# **Terminology around DWDM systems and relation with ITU-T SG15 Recommendations**

IEEE P802.3ct Task Force, Interim Electronic Meeting, 28 January 2021

Figure 154–3—Black link example configuration for specifying n DWDM channels

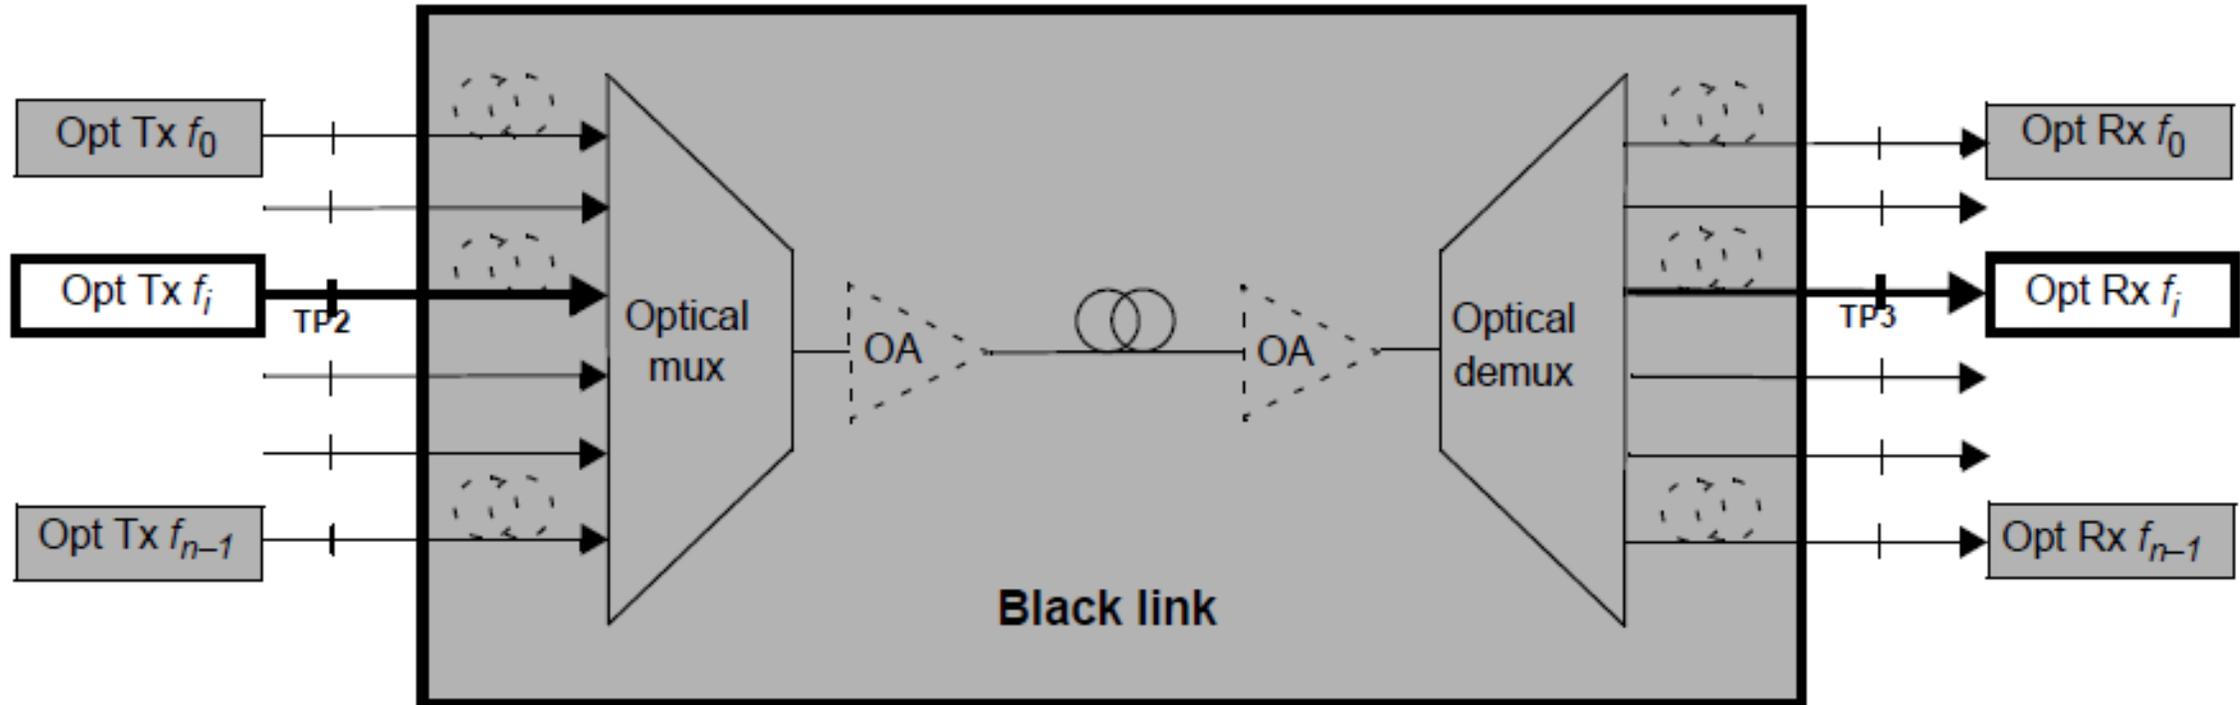
Fully consistent with Figure 5-1 in G.698.2. The transmitter frequency is used instead of transmitter wavelength, no OADM is shown, and “black link” is referred to instead of “DWDM link”.
